MIL-M-28787/71C(SH)
AMENDMENT 5
23 March 1992
SUPERSEDING
AMENDMENT 4
29 March 1991

MODULES, STANDARD ELECTRONIC

SHIFT REGISTER, DIGITAL, KEY CODE CHF

FIGURE 42 Noise sensitivity test circuit waveforms for table XXVI.

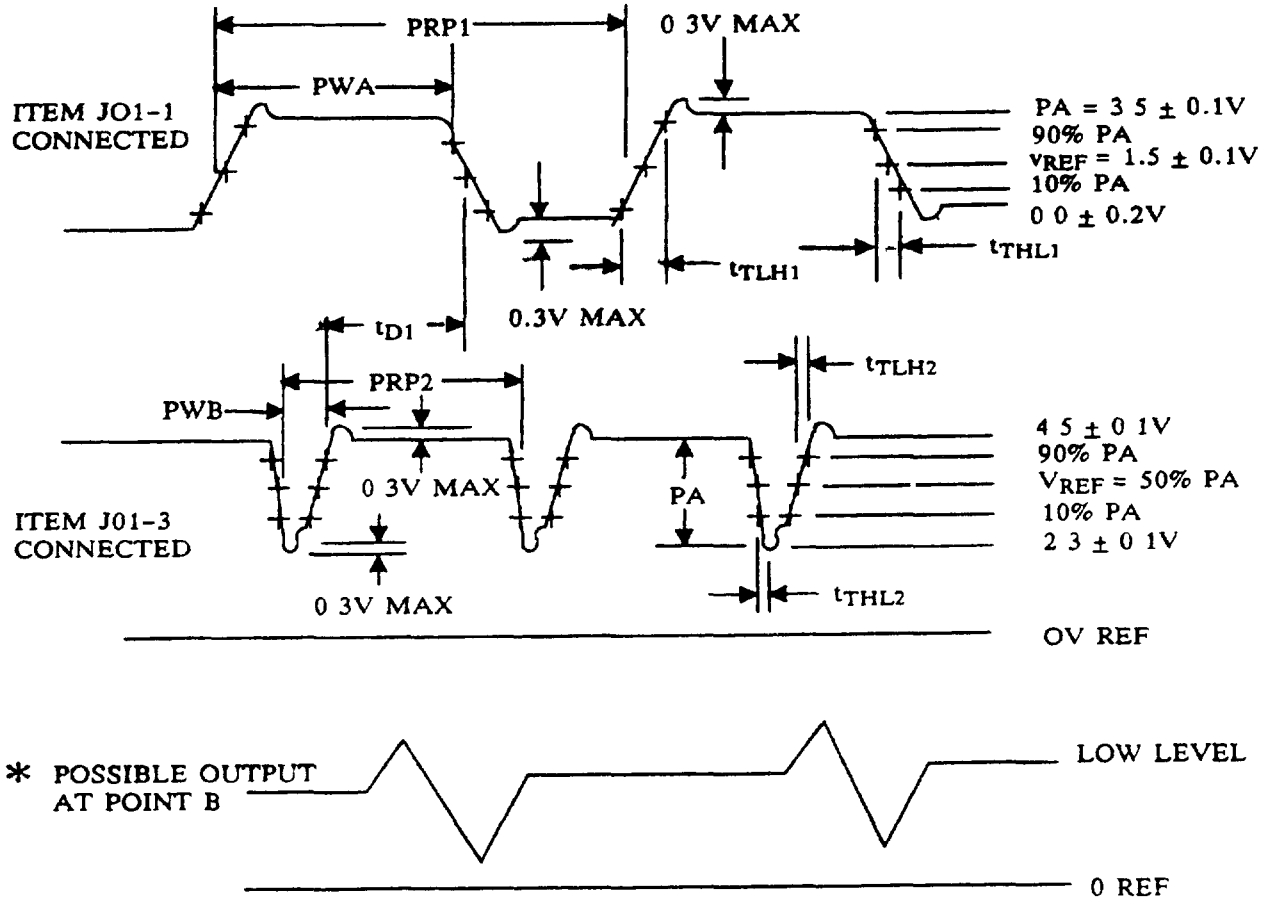
Following figure 41, add new figure 42 as printed on page 5 of this amendment

1 Item J01-1 pulse parameters
PRP1 = 1000 ± 100ns
PWA = 500 ± 50ns
$t_{TLH1} = t_{THL1} =$ 10 ± 2ns
t_{D1} = 100 ± 10ns

2 Item J01-3 pulse parameters
PRP2 = 500 ± 100ns
PWB = 20 ± 5ns
$t_{TLH2} = t_{THL2}$ = 6 ± 2ns

3. The output pulse at point B shall meet the requirements of table XXVI (test conditions AA49-AA64)
